CALIFORNIA CROSSROADS

Stage 4 Road Safety Audit

REPORT NUMBER: UK0045909.0032/RSA4/1/0

DATE: JUNE 2026

Figure 1 – Collision Location Plan

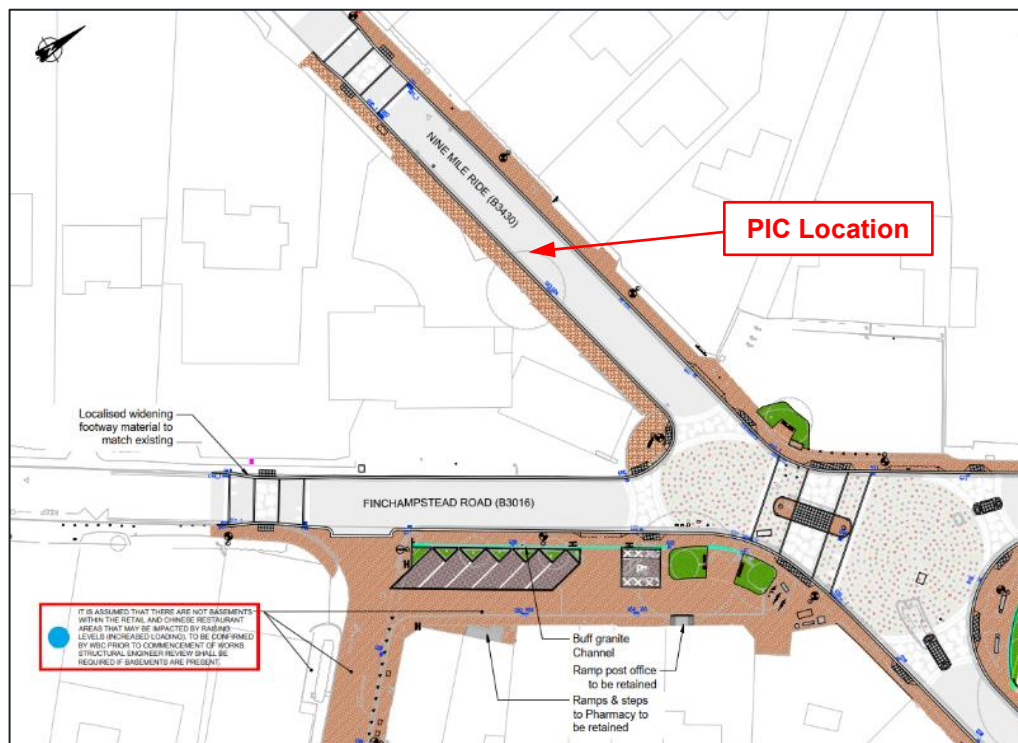
- 2.2.1. The PIC recorded during the 12-month 'post-construction' period was slight in severity and involved a car travelling westbound on Nine Mile Ride colliding with a pedestrian who was crossing the carriageway. This collision took place approximately 30m to the west of the California Crossroads junction, as shown on Figure 1 above.
- 2.2.2. It should be noted that the contributory factor information for this collision indicates the following (in relation to the driver of the motor vehicle):
- Driver was affected by alcohol;
 - Driver was being aggressive, dangerous or reckless; and
 - Ineffective observation by the driver.

2.2.3. Therefore, it could be concluded that this PIC occurred as a result of driver negligence / error, and the highway layout was very unlikely to have been a contributory factor.
